Reference: 335 Roosevelt Avenue
RMA Application
Our File No.: 110098

The city had also provided comments on the Roosevelt Avenue Terminus Design of the Subject Site. The responses to the comments are as follows:

PROJECT No.	124147
REV	REV # 1
DRAWING No.	124147-FD

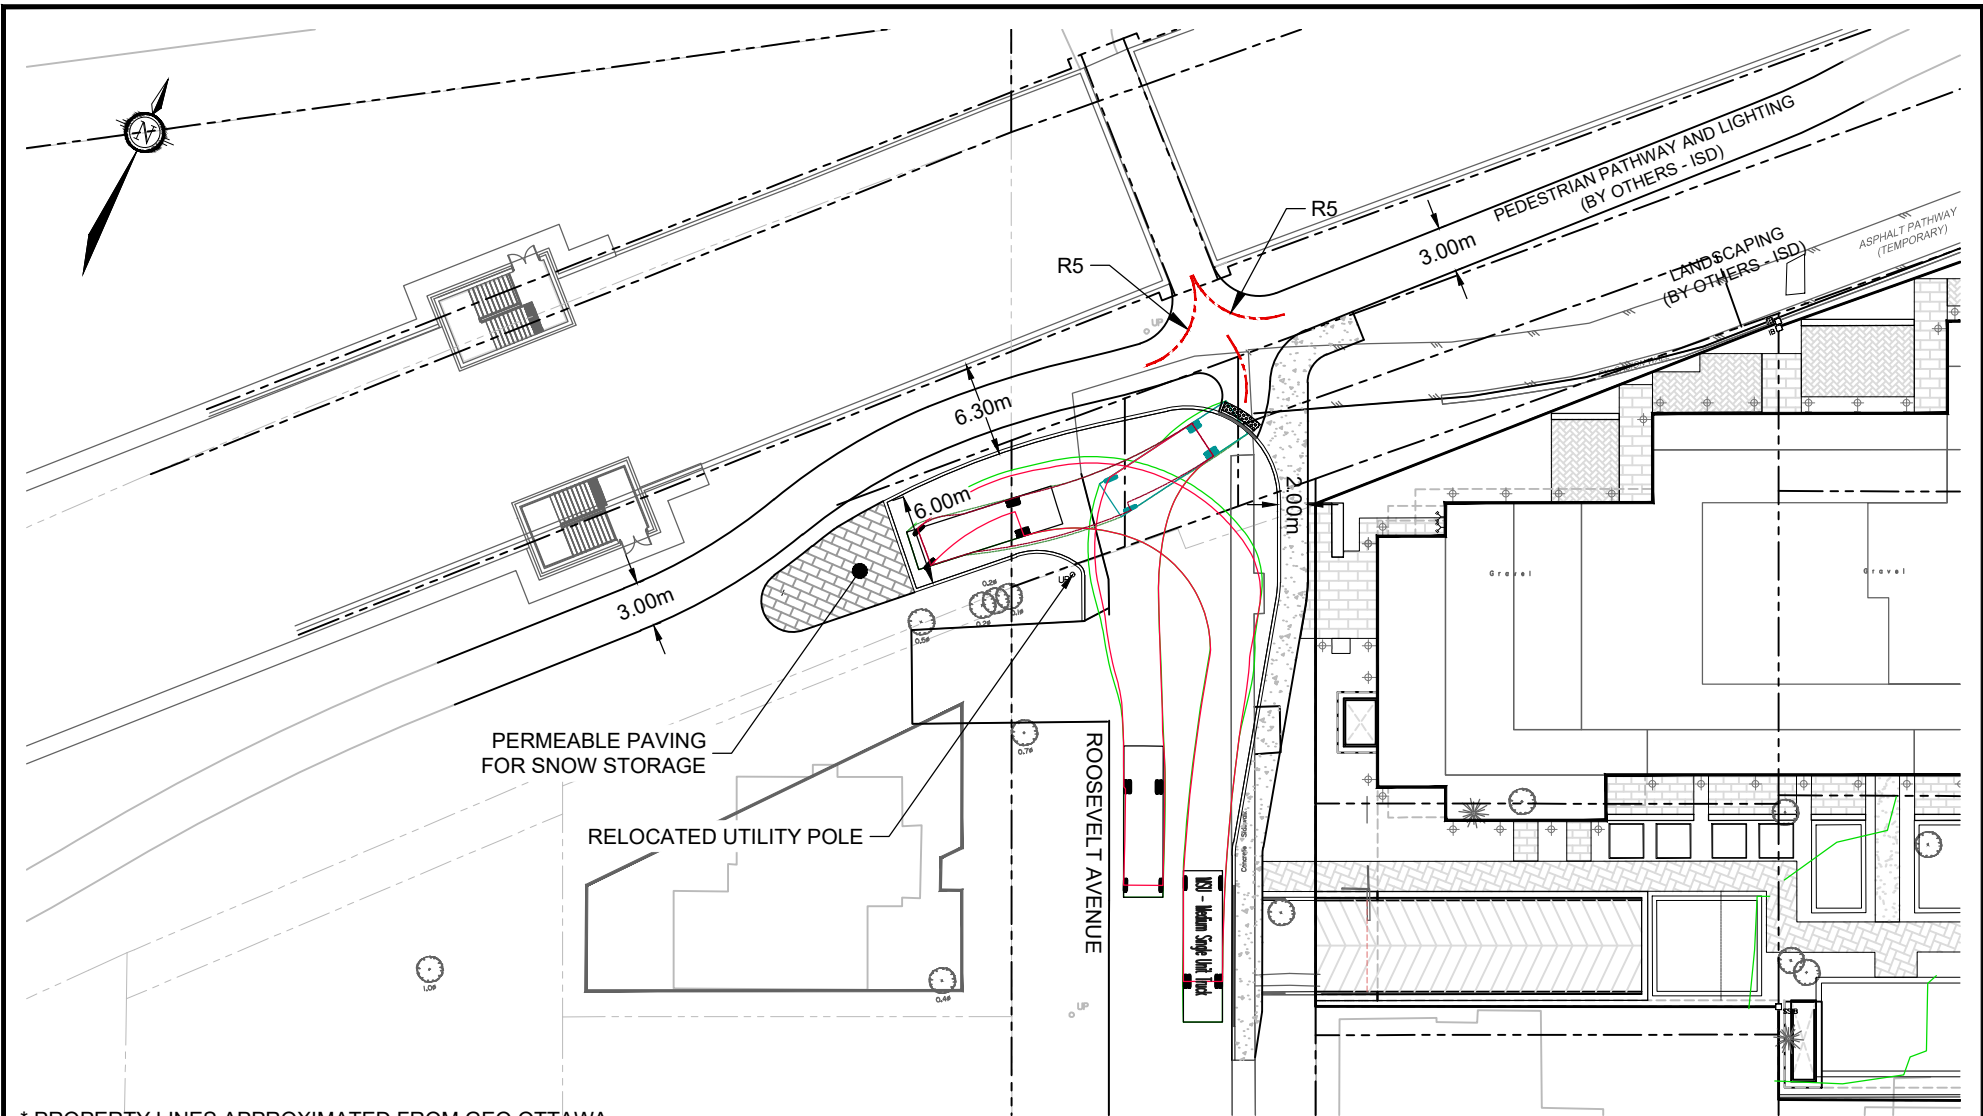
1. To aid turning and potentially limit the overhang of sidewalk during reverse, consider removing curb radius to the east of the utility pole, and instead provide a straight curb to facilitate egress. Refer to markup below.

2. On the west side of the functional design, maintain the alignment of the MUP proposed by Stage 2 LRT for longer to permit larger radii within the MUP "S-bend".

3. Consider a 2.0m-wide sidewalk on the east side of Roosevelt Avenue.

The design has been revised in accordance with the markup provided by the city. As discussed above, the relocation of the utility pole and guy wire is being coordinated with Hydro Ottawa.

The design has been revised in accordance with the markup provided by the city.

The design has been revised to include a 2.0m wide sidewalk.

FIGURE FIGURE 1

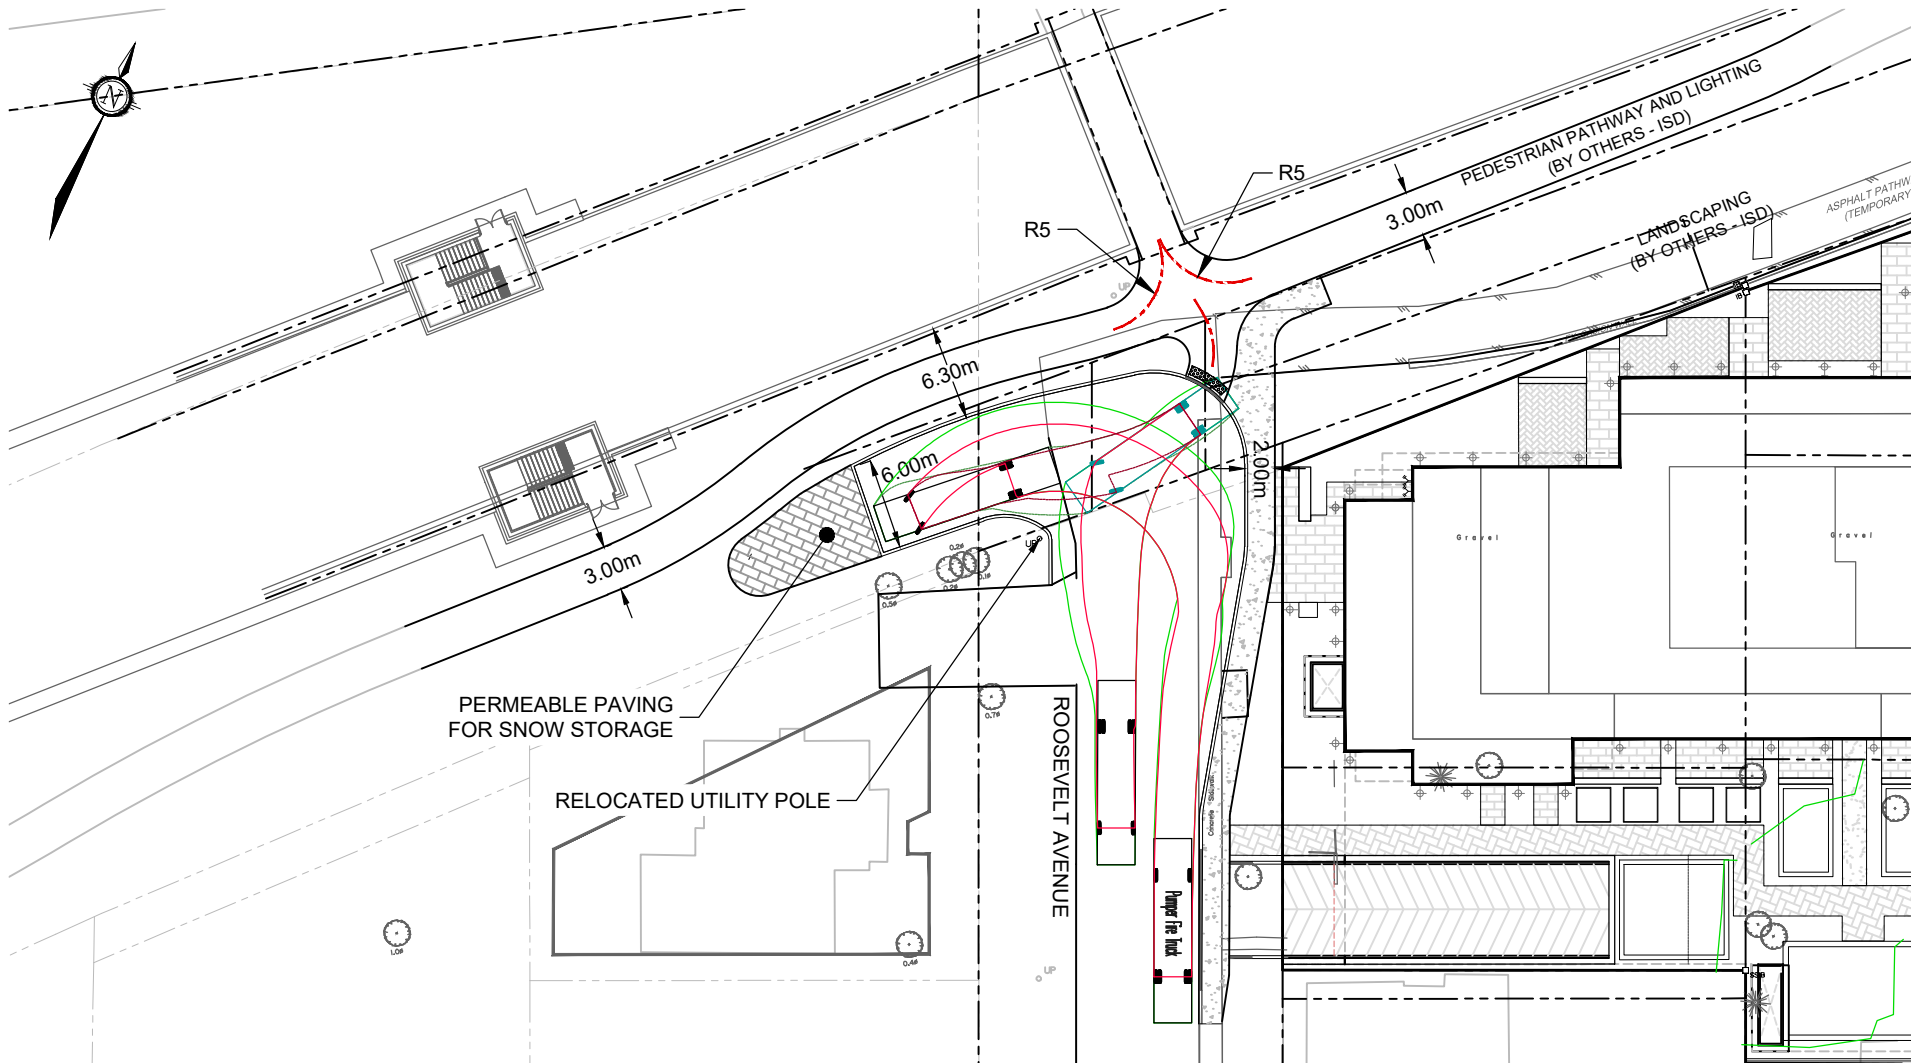
5. Turning movements show MSU & Fire Truck swept path encroaching over the MUP and the sidewalk while reversing. Road designs should allow vehicles to complete turns safely and

efficiently without the need for reversing over pedestrian and cycling facilities. Such reversing maneuvers could pose safety risks, especially in areas with high pedestrian activity. Consideration to relocate the utility pole is still recommended to limit/prevent this conflict, though AT Planning recognizes this has previously been requested and rejected.

Novatech Response

The available area is insufficient to accommodate a traditional cul-de-sac to eliminate backing up. The MSU (fire truck/garbage truck/moving vehicles) that has its overhang over the sidewalk while reversing is infrequent. Also, the loading procedures for the west building will be off Winston Avenue. Fire trucks will have flasher/sirens to enforce the right-of-way. As discussed above, the relocation of the utility pole and guy wire is being coordinated with Hydro Ottawa.
